M E M O R A N D U M

RE: Off Forest Street
Carver, Massachusetts

Fuss & O'Neill has reviewed a response to comments letter dated May 1, 2020 and revised applications documents which were prepared by Flaherty & Stefani, Inc. Fuss & O'Neill has prepared the comments in this memorandum based on our review of the following documents:

**SITE AND LANDSCAPING PLAN
IN
CARVER, MASSACHUSETTS**

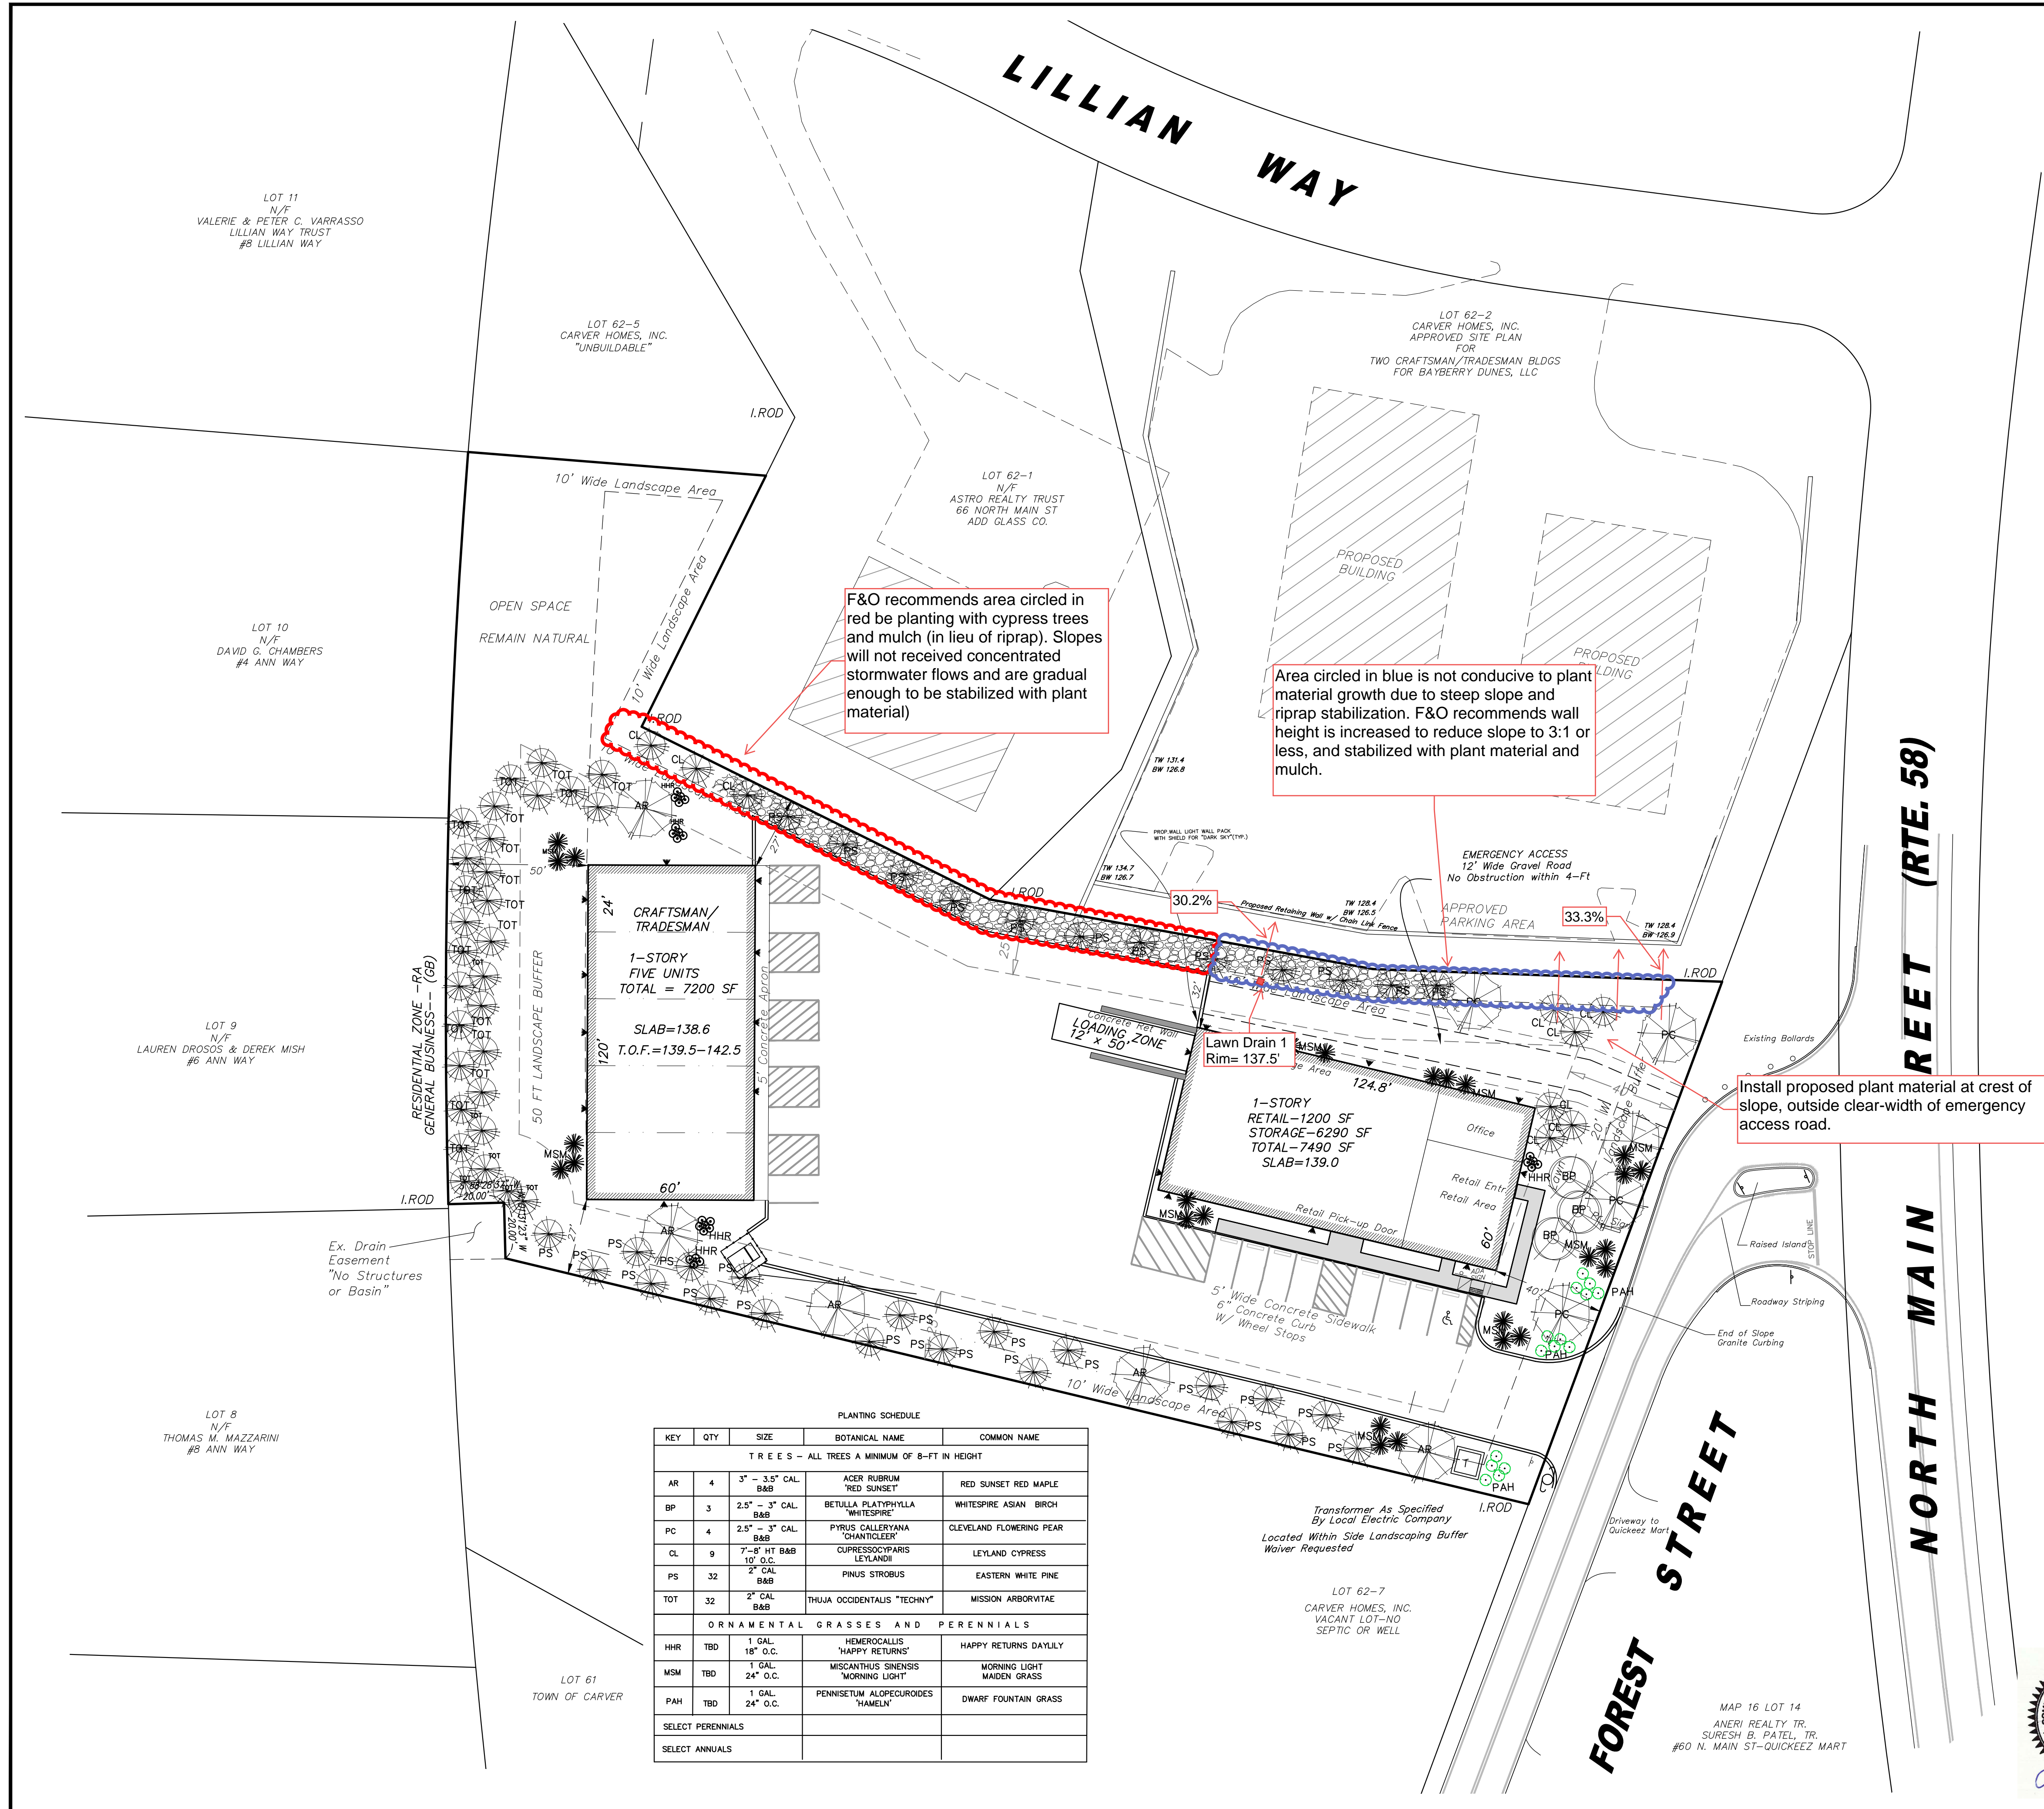
1. Site and Landscaping Plan (3 of 12)
 - 1.1. See the attached markup of Site and Landscape Plan for revisions recommended along the northern landscaped buffer. Plantings are not recommended to be installed within slopes that are greater than 3:1 and stabilized with rip rap.

F&O recommends area circled in red be planting with cypress trees and mulch (in lieu of riprap). Slopes will not received concentrated stormwater flows and are gradual enough to be stabilized with plant material)

Area circled in blue is not conducive to plant material growth due to steep slope and riprap stabilization. F&O recommends wall height is increased to reduce slope to 3:1 or less, and stabilized with plant material and mulch.

Install proposed plant material at crest of slope, outside clear-width of emergency access road.
